CONSERVATION TEAM CONSULTATION APPLICATION RESPONSE

APPLICATION REF:	25/01581/FPH & 25/01582/LBC
CASE OFFICER:	VW
APPLICATION SITE:	188 Park Lane, Old Knebworth, Knebworth, Hertfordshire SG3 6PS
DESCRIPTION OF WORKS:	Replacement rear French doors. Single storey extension to existing detached garden room to facilitate office space. Replacement rear French doors and internal alterations.

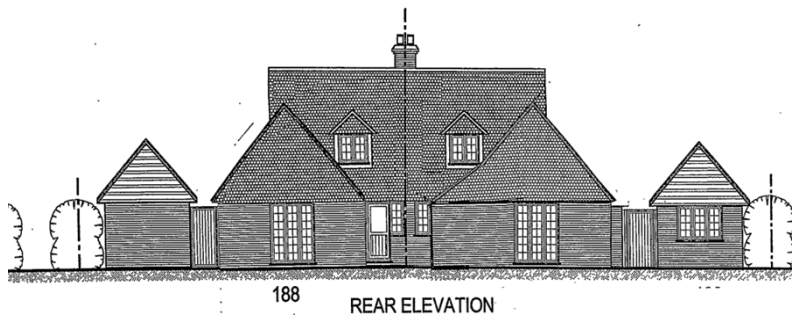
The single-storey, rear extension was granted consent/permission under application refs: 97/00601/1LB and 97/00664/1HH (see approved drawing below). The doors were afforded the same detailing as the host building with the Principal Conservation Officer at the time stating that *'all new window patterns will exactly match existing'*.

What currently exists is either what was originally implemented, thus not in accordance with the approved plans or these doors are plain glazed replacements without the benefit of listed building consent.

Had it not been for the fact that the host building is Lutyens-designed I may have been slightly less concerned with the proposed sidelights, but it is important that alterations / additions are sympathetic and maintain the quality of Lutyens' work.

Although the proposal will not result in the loss of historic fabric, the opening-up of this aperture with wide sidelights will, in my opinion, have a mildly erosive impact on the listed building. A far better arrangement and a good compromise that would allow more natural light, would be to reinstate French doors with glazing bars and perhaps narrower, half-height sidelights with window sills.

- **85/00922/1LB - Removal of two internal walls.**
CON 24.07.1985

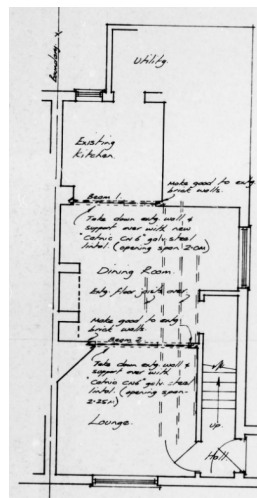
I note that the wall proposed to be removed is a load bearing one and forms part of the building's original construction.

The wall in question is one of the two internal walls that was granted listed building consent in 1985 (see below) and if a material start was made to that consented scheme, then procedurally it may be concluded that this opening-up work has the benefit of an extant consent.

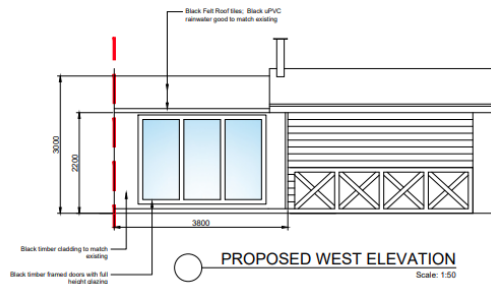
Although the loadbearing wall was consented to be removed in 1985, the corner stack remained intact on the ground floor. In the 1997 scheme the corner stack is shown truncated, and a material start was made to that consented scheme so works to the stack are consented. If the stack remains intact and considering that I have not been to site or seen a photo of the corner stack I am currently unable to say whether harm would be occasioned to this listed building.
